**New Albany Planning Commission  
Meeting Minutes - Approved  
Monday, December 4, 2023**

Request to rezone 12.737 acres located at 7270 New Albany Condit Road in Franklin County from Infill Planned Development (I-PUD) to Limited General Employment (L-GE) for an area to be known as the North City Business Zoning District (PIDs: 222-005258 and 222-005259).

Re: Cornerstone -  
Rezoning

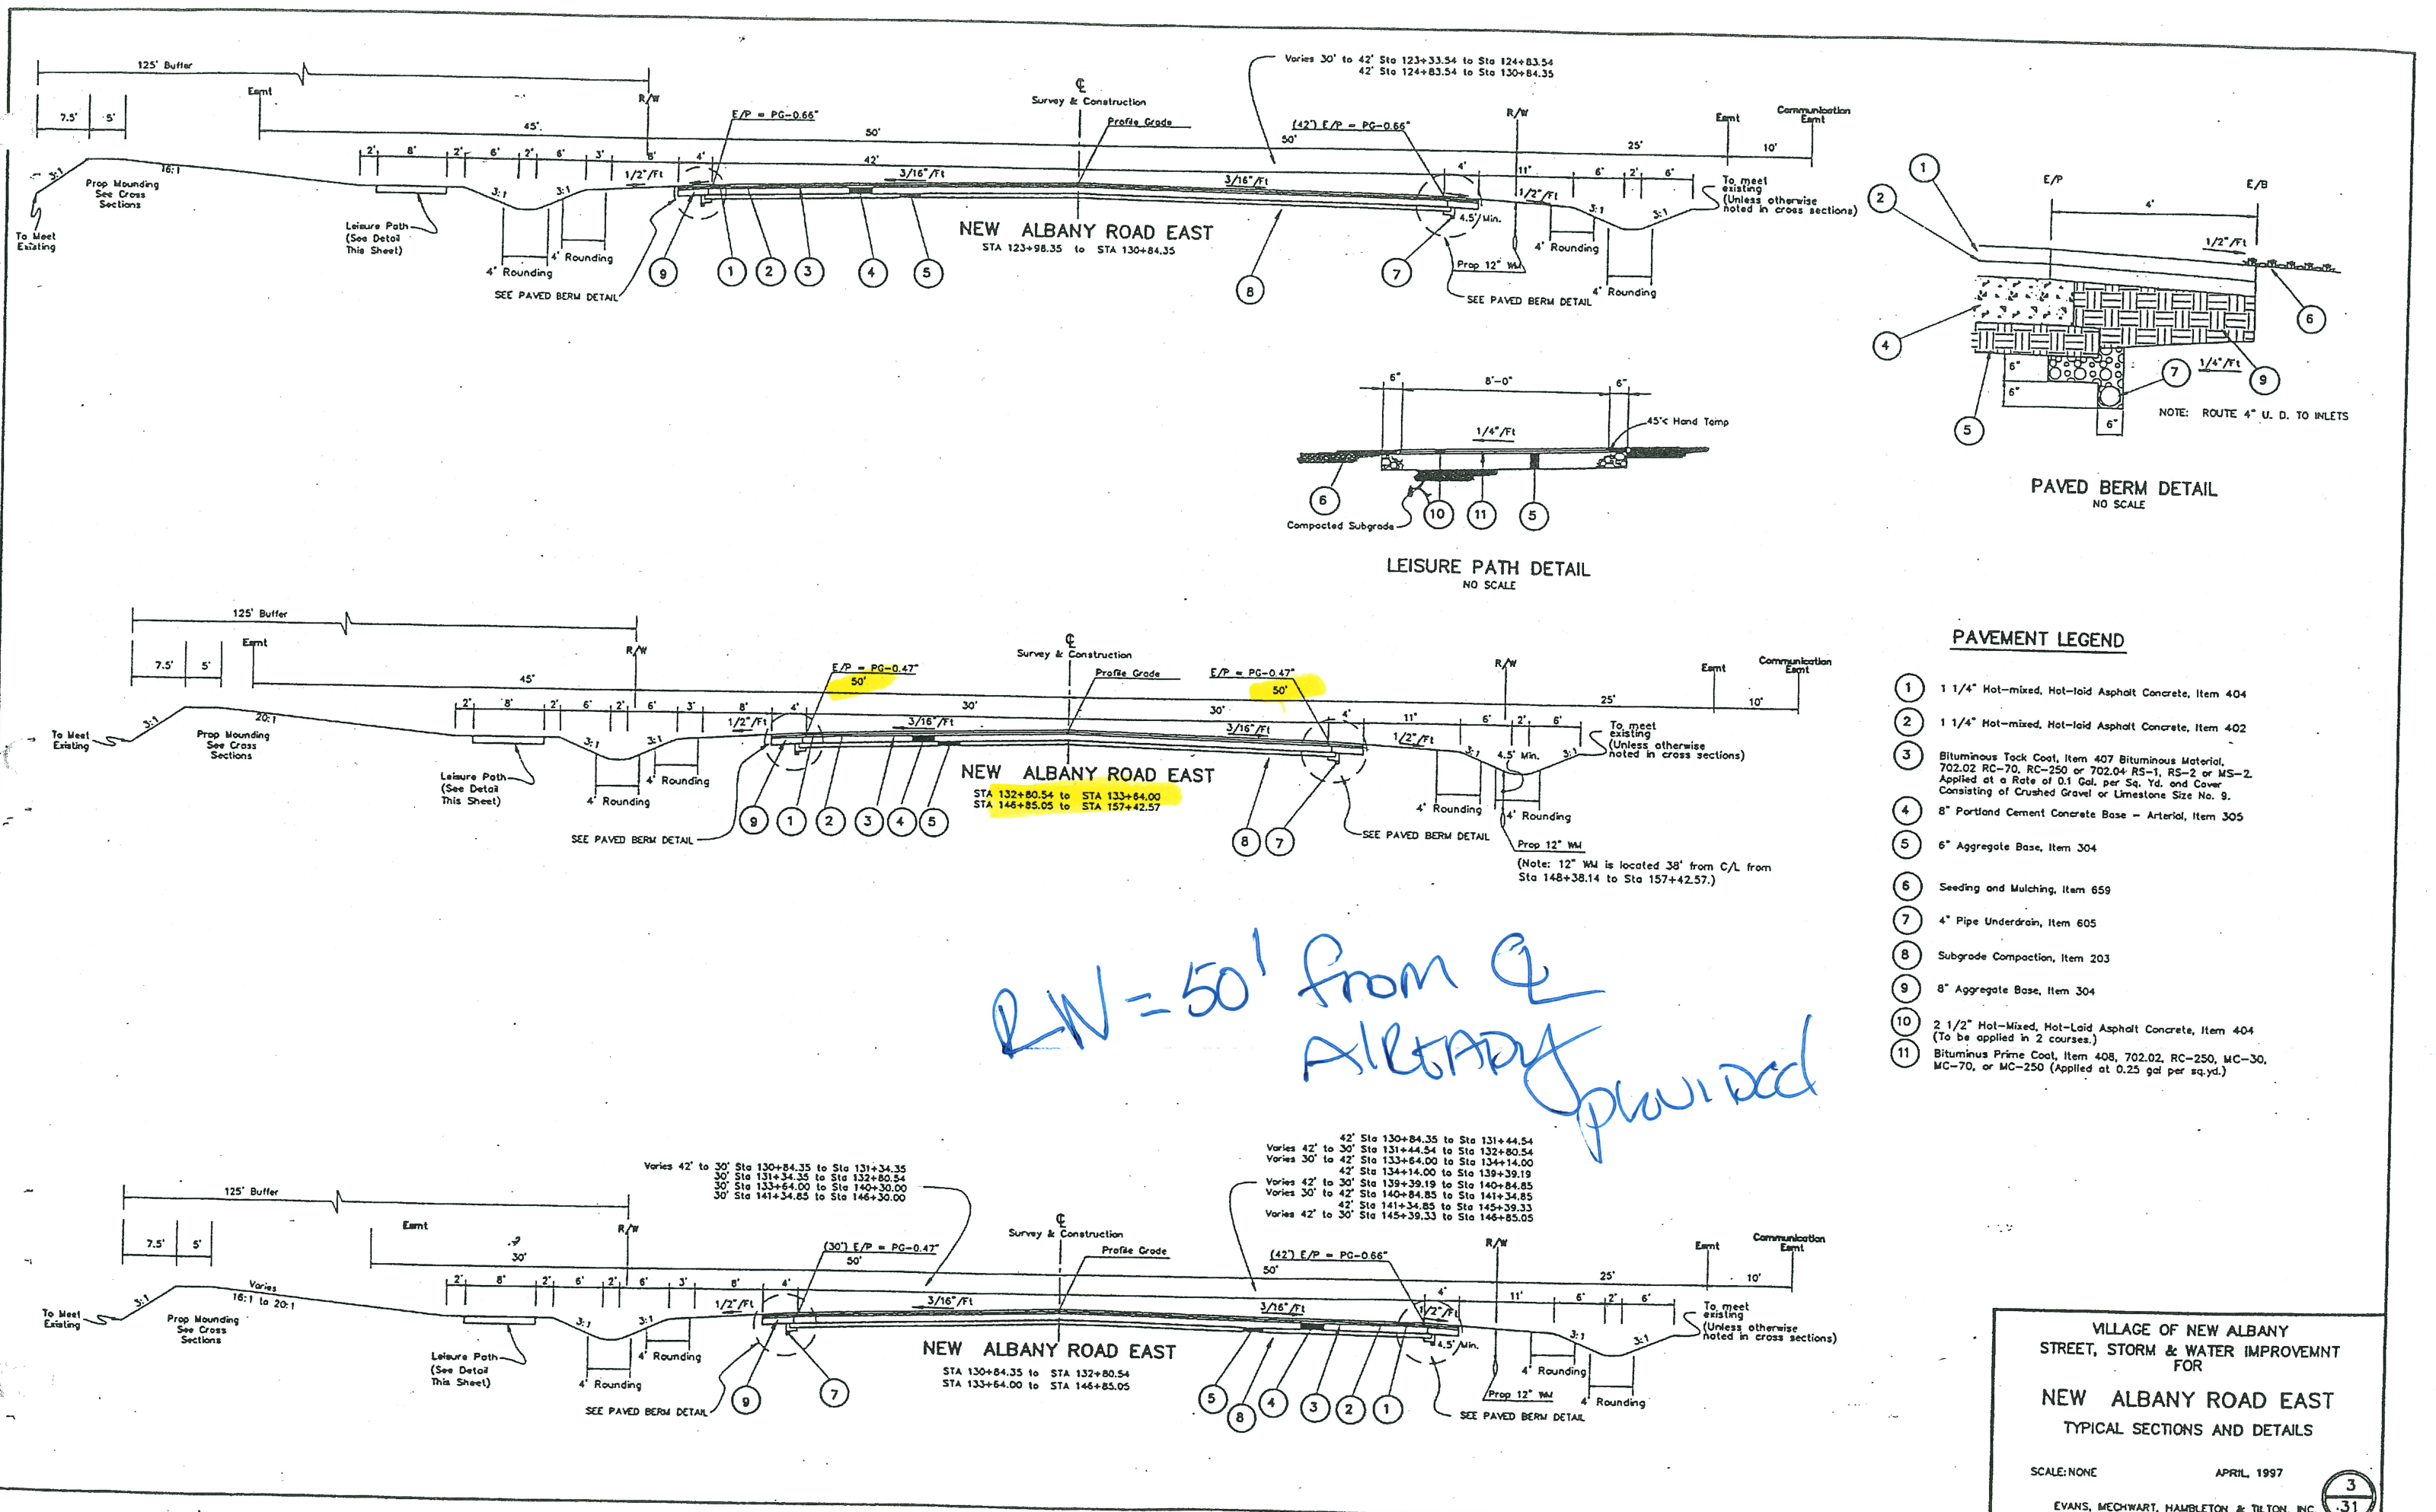
- 1) We will require a Traffic Impact Study for review and approval once a development project is identified for this site.
- 2) The rezoning text states that 50' of public r/w as measured from road centerline will be provided along NA Road East and SR 605. This condition is already met along NA Road East. An additional 10' of public r/w will need to be dedicated along SR 605 where 50' is not already provided.

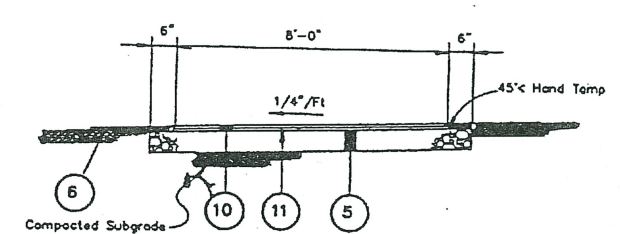
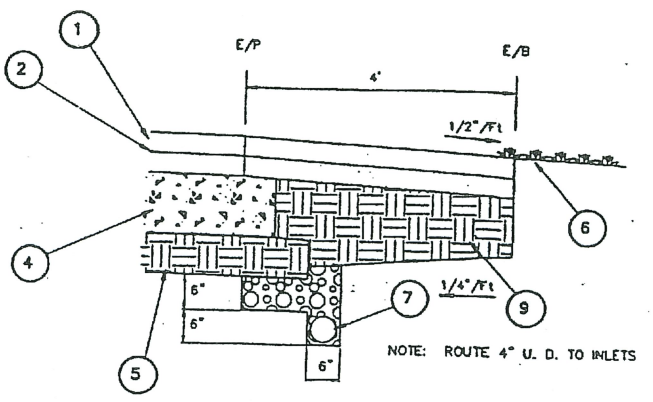
R/W = 50' from CL  
ALREADY PROVIDED
